**SUBMITTAL TO THE BOARD OF SUPERVISORS
COUNTY OF RIVERSIDE, STATE OF CALIFORNIA**

SUBJECT: TRANSPORTATION AND LAND MANAGEMENT AGENCY/TRANSPORTATION:
Approve Addenda to the Plans and Specifications, Accept the Low Bid and Award the Contract for the Construction of Slurry Seal and Curb Ramp Accessibility Project for Fiscal Year 2021/22 at various locations; District 1. [\$2,405,843 Total Cost - Local Funds 100%] (Companion Item to MT No. 17974 and 17975)

The addenda were issued to clarify and modify the approved contract documents. The addenda are attached and designated as Addendum No. 1 and Addendum No. 2.

**SLURRY SEAL and
CURB RAMP ACCESSIBILITY PROJECT
FOR FISCAL YEAR 2021 - 2022
DISTRICT 1, PROJECT No. D2-0006, D2-0011**

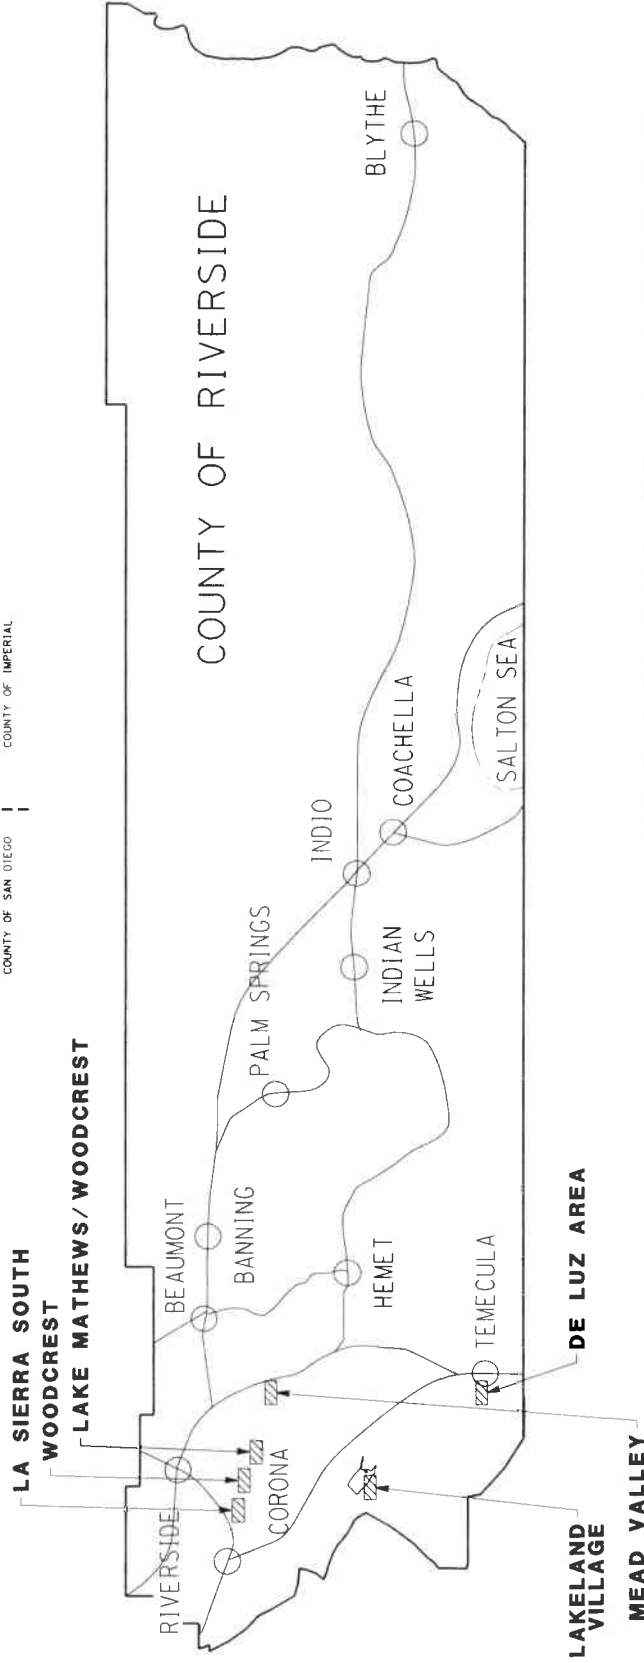
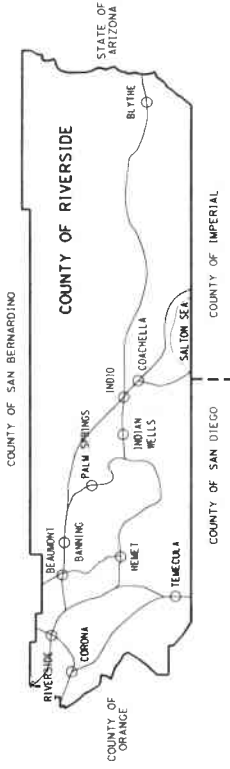
- Refer to General Note No. 1 on sheet 1 of 39.

— Edition of the Standard Plans and Specifications was revised from 2015-to-2018.

1. ALL MATERIAL AND WORK SHALL CONFORM TO THE 2018 EDITION OF THE SPECIFICATIONS AND REQUIREMENTS OF THE STATE OF CALIFORNIA.
2. LOCATIONS OF ALL UNDERGROUND UTILITIES ARE APPROXIMATE. VISIT ALL CONDITIONS ON THE JOB SITE PRIOR TO COMMENCING ANY AND ALL DAMAGE PREVENTION MEASURES. THE CONTRACTOR SHALL EXERCISE DUE CARE TO PROTECT ALL UTILITIES AND ALL CONCERNED UTILITY COMPANIES AT LEAST 48 HOURS IN ADVANCE. CONTACT THE UTILITY COMPANIES AT LEAST 48 HOURS IN ADVANCE TO EXACTLY LOCATE AND PRESERVE ANY AND ALL UNDERGROUND UTILITIES. CALL UNDERGROUND SERVICE ALERT AT (800) 227-2600.
3. ALL CRIBS SHALL BE CONFORM TO CLASS ES-14 AND ES-18 FOR SYMBOL.
4. EXISTING PRIVATELY OWNED IMPROVEMENTS OR PUBLIC RIGHT-OF-WAY ARE TO BE MAINTAINED AND NOT TO BE REPLACED OR DAMAGED, AS DIRECTED BY THE ENGINEER.
5. CONTRACTOR LICENSE CLASS A OR C-12 REQUIRED.

SHEET 2 of 39

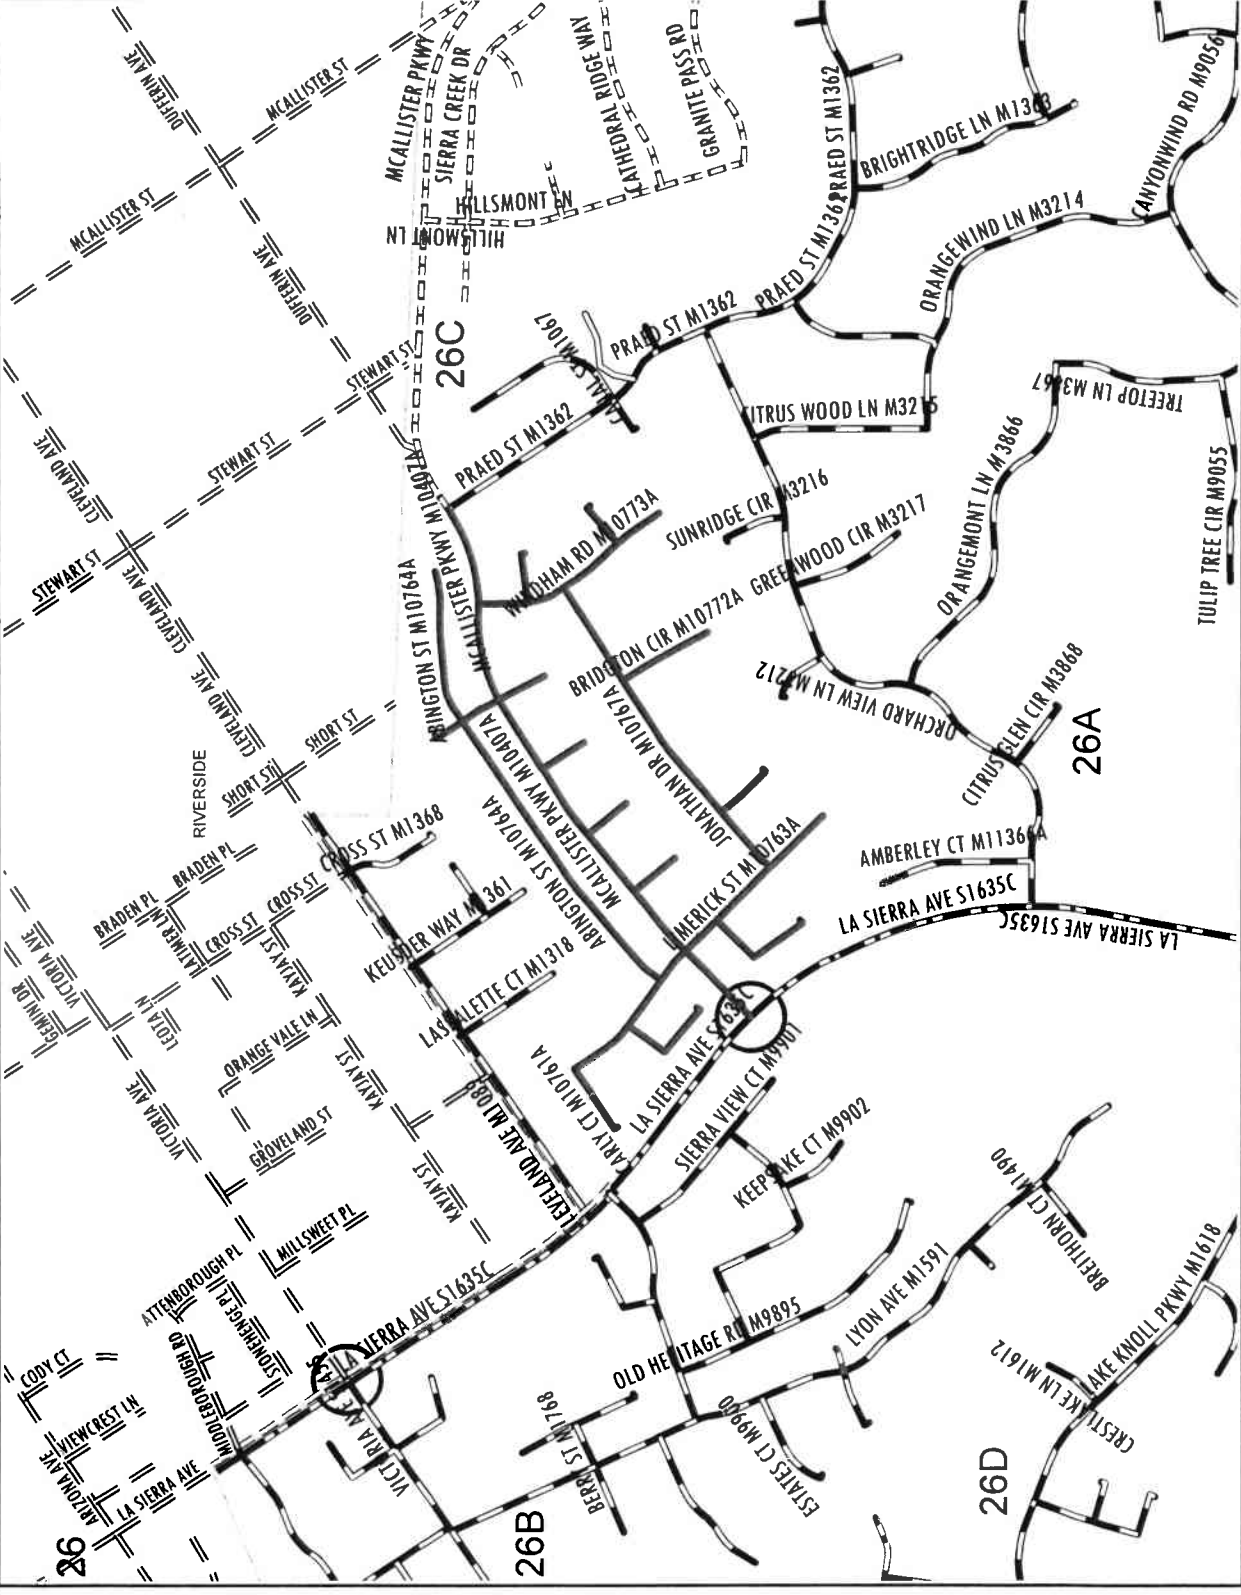
- Refer to Signalized Curb Ramps Table on sheet 2 of 39.

Sheet numbers shown on table for curb ramps were revised to show the correct reference sheet numbering (sheet 14-19). Also, ramps listed but excluded from the project have been struck through.
